**FINAL DRAINAGE LETTER for
CROSSROADS MIXED USE FILING NO. 1
UNDERGROUND DETENTION**

DECEMBER 2022

RE: Drainage Letter for Crossroads Mixed Use Filing No.1 Underground Detention

**CROSSROADS MIXED USE FILING NO. 1
-PLAT**

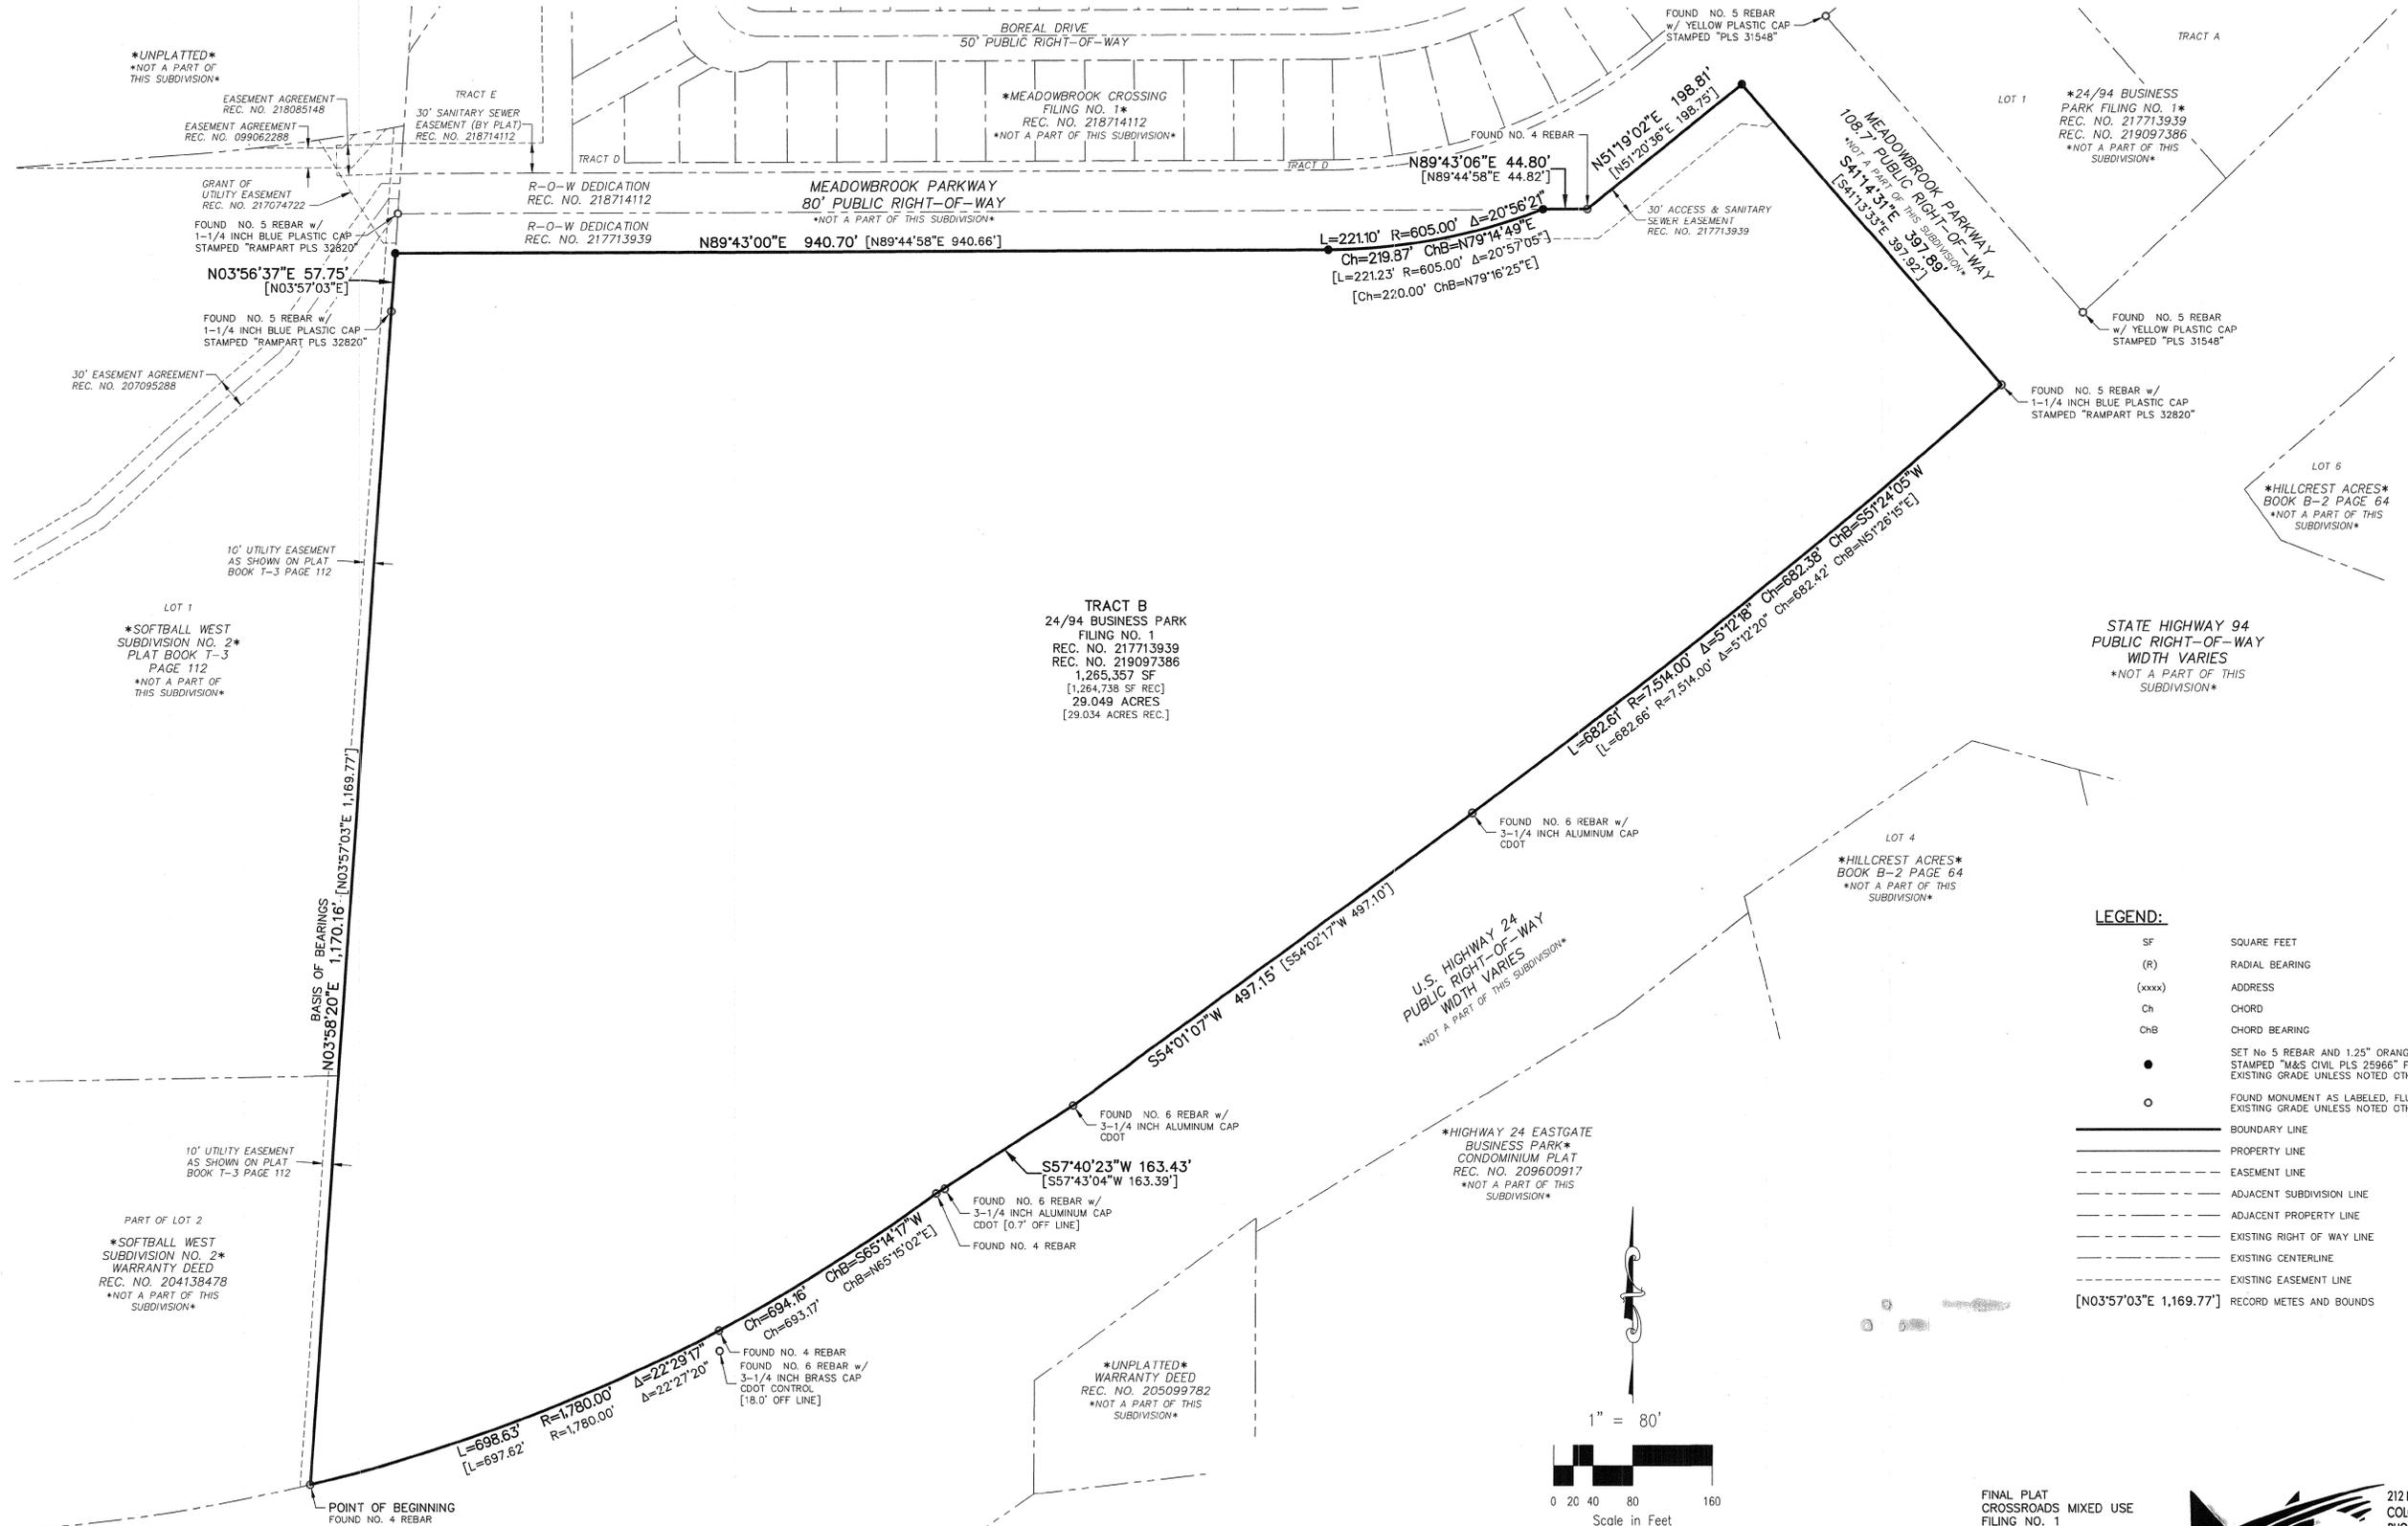
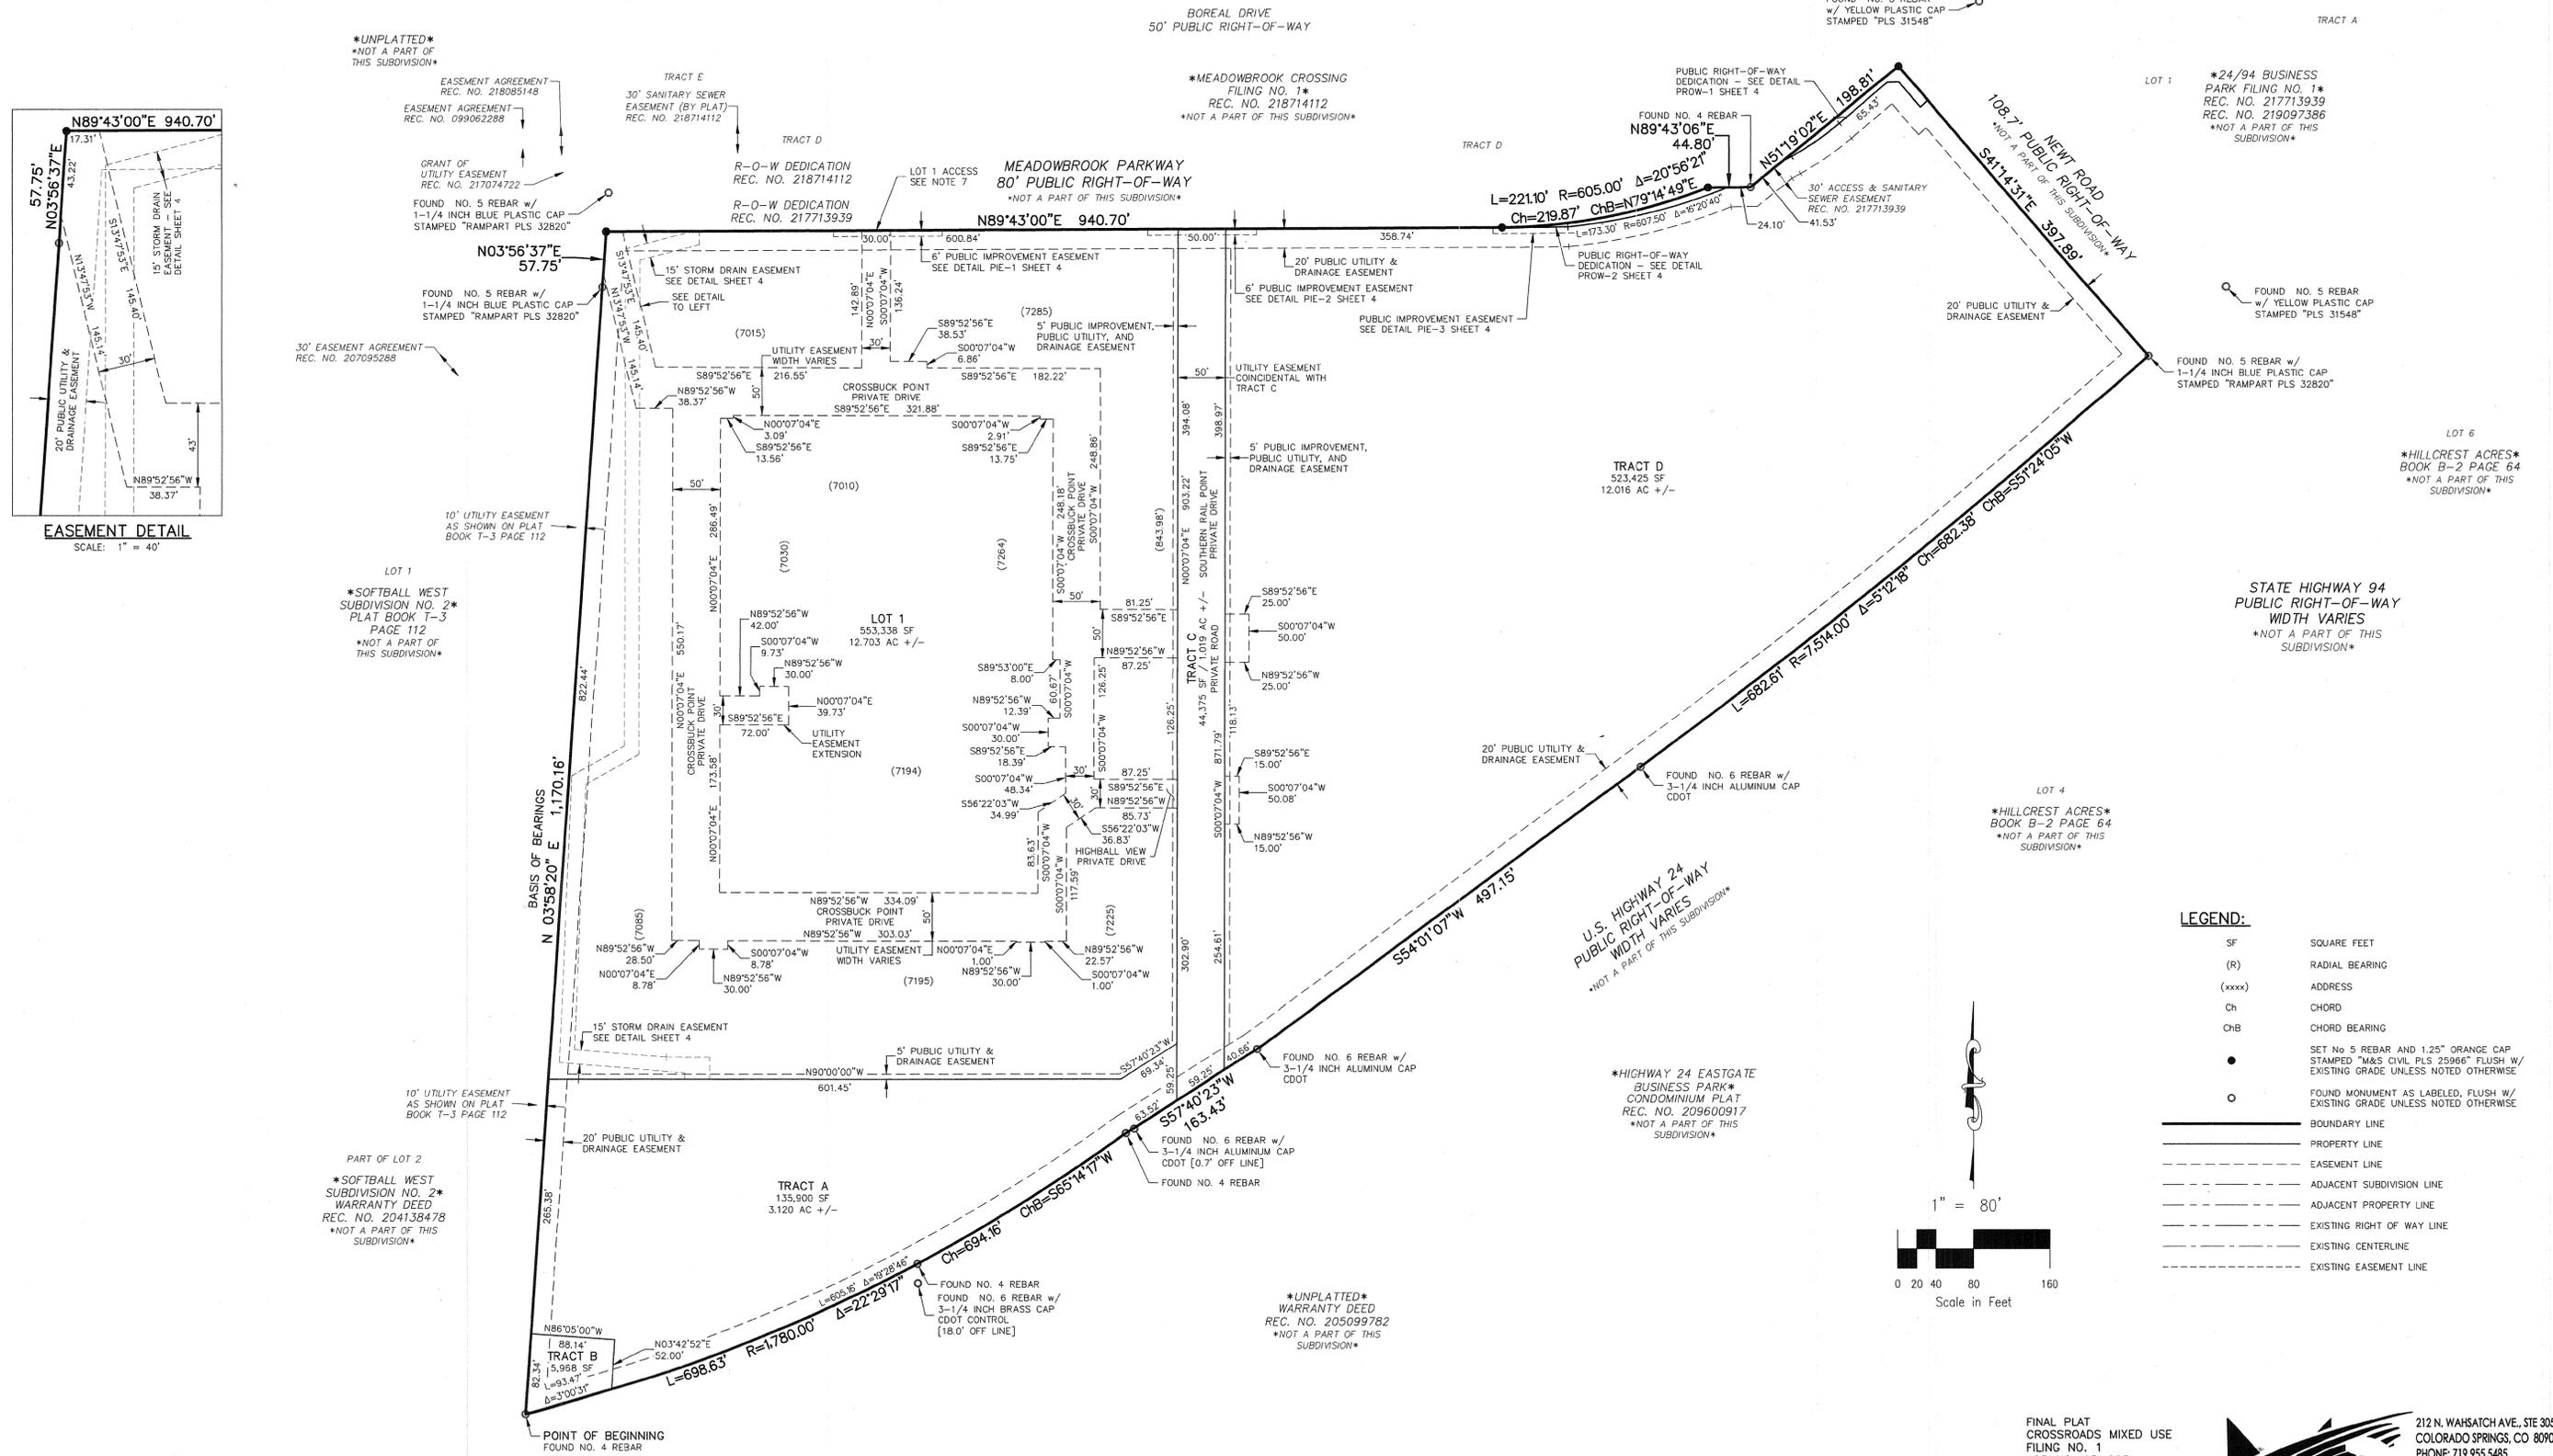
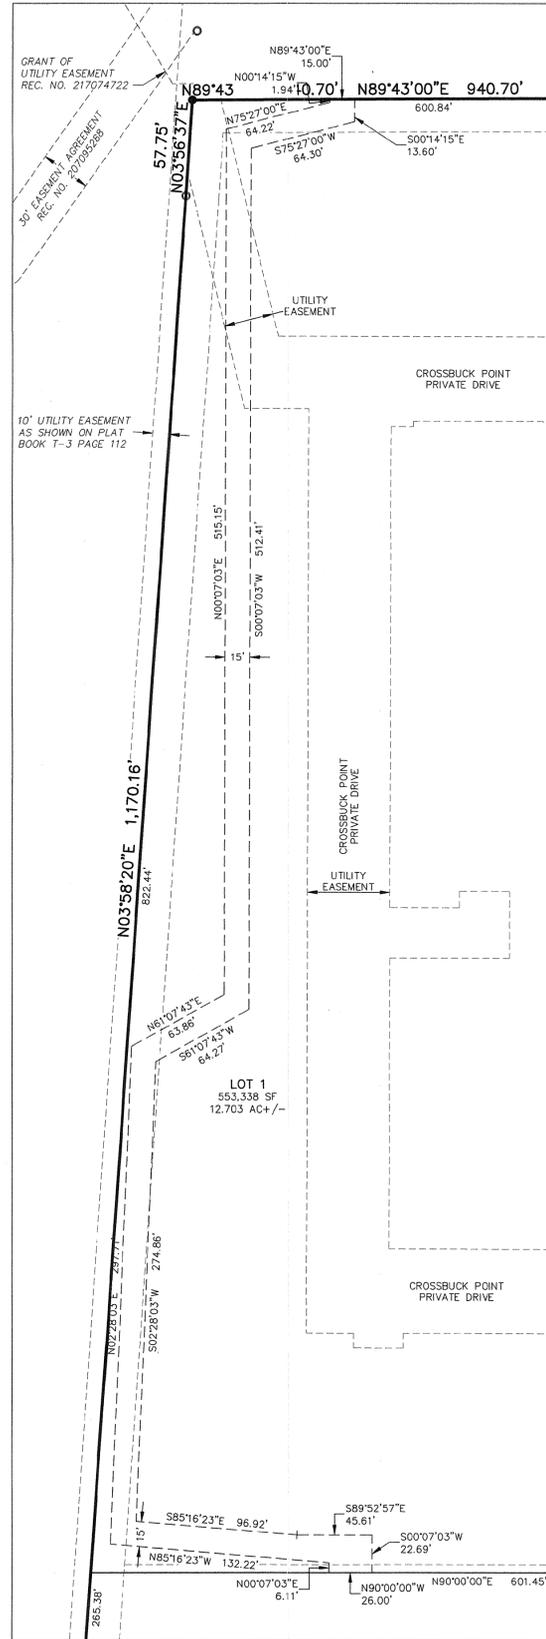
Remove Plat document.
